Subject: Nuclear Industry Advisory

NUCLEAR INDUSTRY ADVISORY

Barton Model 763, Model 763A and Model 764 Zener Diodes

Larger Commercial Zener Diode & Smaller Similar Glass Body JANTX Zener Diode

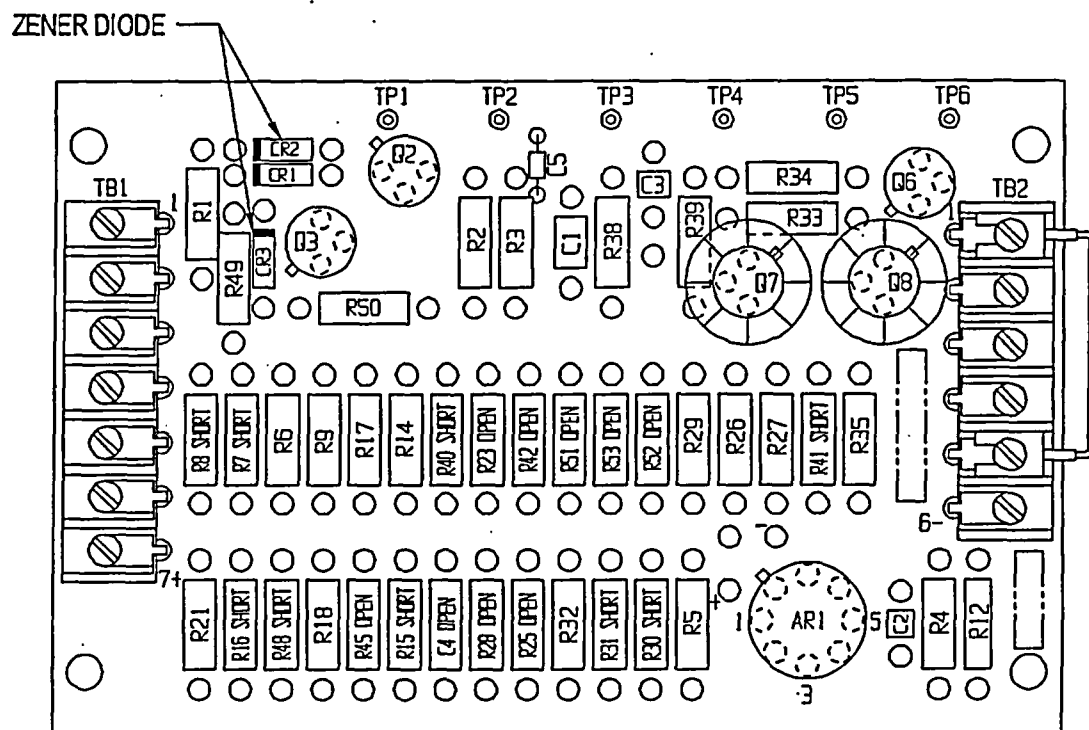
The JANTX Zener diodes are different in appearance with respect to the commercial variations. Some JANTX Zener diodes used in the recent past have bodies that are solid orange or light blue in color or clear glass. The commercial Zener Diodes that have been used have a body that is clear glass. The attached photo compares the larger commercial Zener diode (0.095" diameter X 0.275" long) with the smaller JANTX Zener diode (0.072" diameter X .155" long) that has a glass body. The existence of the commercial Zener diode can be verified by visual inspection. Remove the transmitter electronics cover and visually observe the Zener diodes at locations CR2 and CR3 as shown on the attached drawing of the circuit board.

Although the commercial Zener diodes perform within acceptable limits, they do not perform as well as the JANTX parts. Furthermore, while PRIME believes that our manufacturing processes screen parts for performance similar to the MIL SPEC applicable to the JANTX parts, we have not performed thermal aging and other tests to validate the qualified life of the commercial Zener diodes. PRIME is therefore offering to rebuild the transmitters containing the commercial Zener diodes, at no customer expense, using two new JANTX Zener diodes. It is recommended that all transmitters with commercial Zener diodes be returned to the factory for Zener diode replacement as soon as practicable. In this replacement, the transmitters will be recalibrated and temperature compensated to the original transmitter factory performance requirements and as tested nuclear qualified configuration.

The Zener diodes are not field replaceable, as it is necessary to electronically reestablish the calibration zero which will likely necessitate replacement of a calibration resistor. This calibration resistor is located in a very temperature sensitive portion of the electronic circuit requiring thermal performance validation.
